SLIDEOUTS

INNER TUBE ASSEMBLY REVISION ON THROUGH FRAME SLIDEOUTS

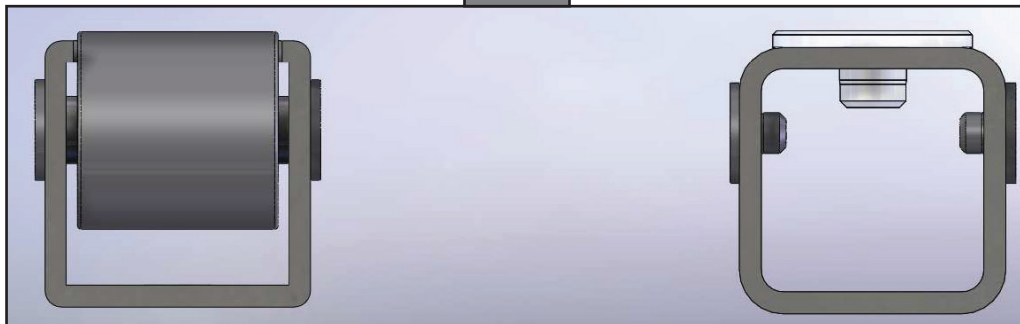
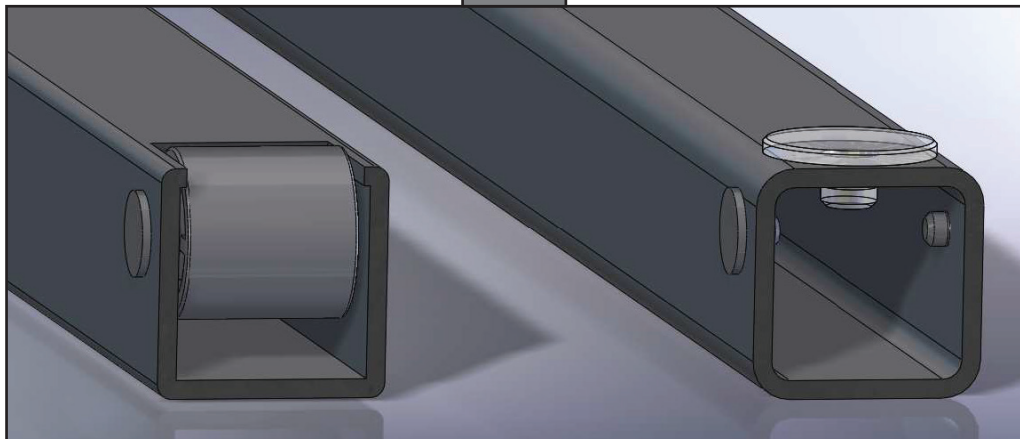
A revision has been made to the Inner Tube Assembly on Through Frame Slideouts. The Rear Roller (104475) and Roller Shaft (105893) have been removed and replaced with a Wear Tab (277882). These new Inner Tube Assemblies are 100% interchangeable with the former design. This change was made to reduce noise created by the Rear Roller. See the illustrations below. See Page 2 for a part number comparison chart between the old version and new version.

Old version with Rear Roller
(104475), Roller Shaft (105893), and
Inner Tube Assembly (See Page 2)

New version with Wear Tab
(277882) and Inner Tube
Assembly (See Page 2)
